APPLICATION NO.	FILING DATE	FIRST NAMED INVENTOR	ATTORNEY DOCKET NO.	CONFIRMATION NO.
10/054,257	01/22/2002	Frederick R. Bean	TN-2239	3692
7590 12/19/2005			EXAMINER	
Adan Ayala, Esq. Black & Decker Inc. 701 E. Joppa Road, TW-199 Towson, MD 21286			NGUYEN, PHONG H	
			ART UNIT	PAPER NUMBER
			3724

Office Action Summary	Application No. 10/054,257	Applicant(s) BEAN ET AL.	
	Examiner Phong H. Nguyen	Art Unit 3724

DETAILED ACTION

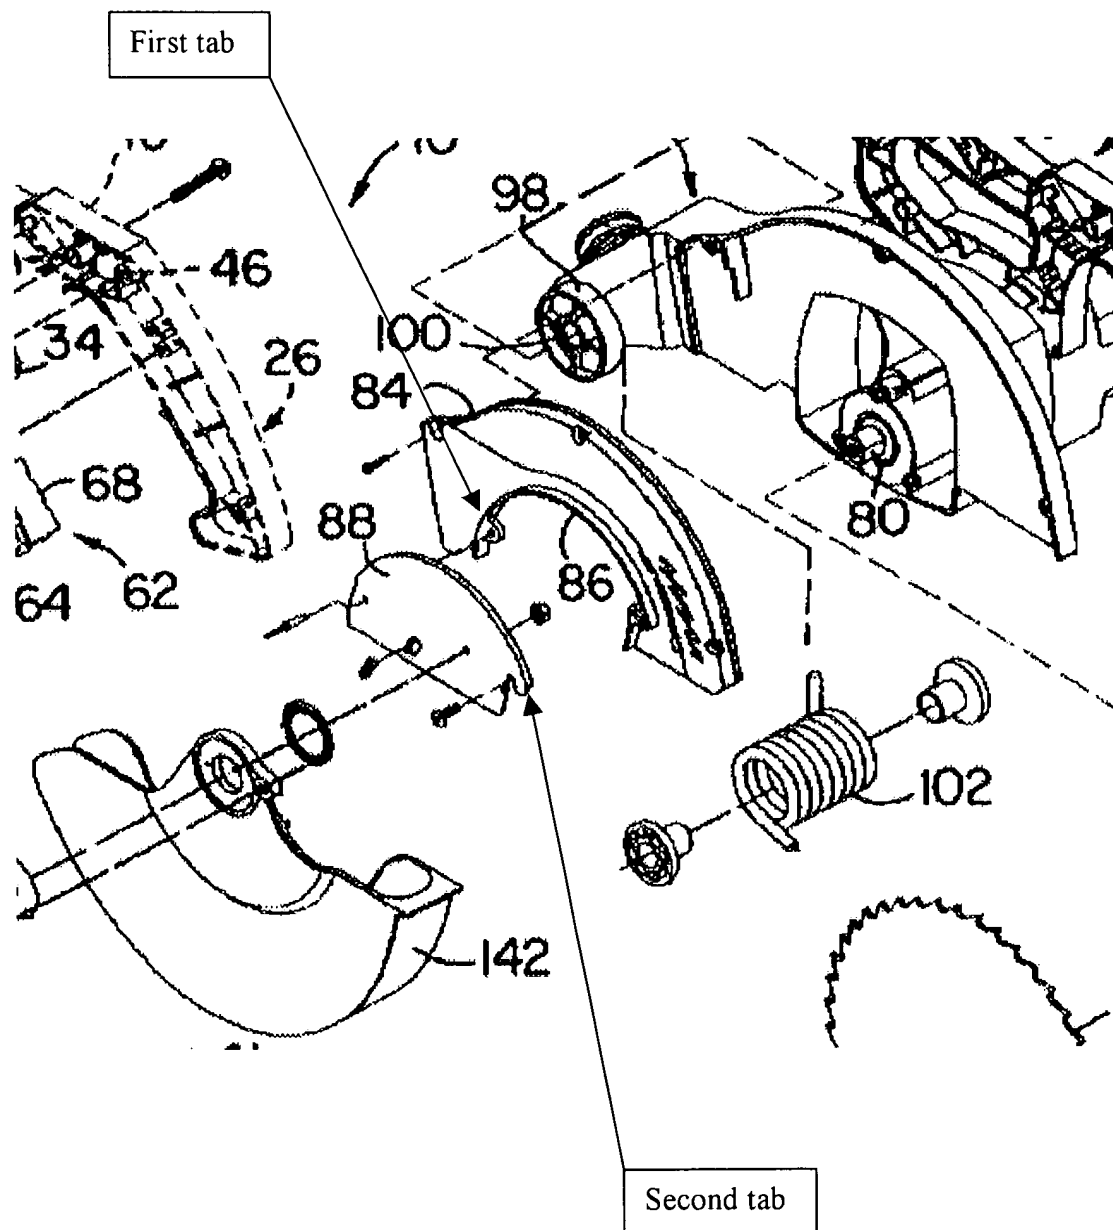
11. Claim 9 is rejected under 35 U.S.C. 102(b) as being anticipated by Chang (5,855,366).

It is to be noted that since the fence assembly 20 is called both a fixed fence and a sliding fence and there is no other description of the fixed fence and the sliding fence in

the Specification, the Examiner calls the fence assembly 20 in Chang both a fixed fence and a sliding as the Applicant does so.

Chang teaches a miter saw comprising a base assembly, a turntable, a saw assembly, a fixed fence 22, a sliding fence 22 and a hole 215 for fixing an end stop fixture. See Figs. 1 and 2.
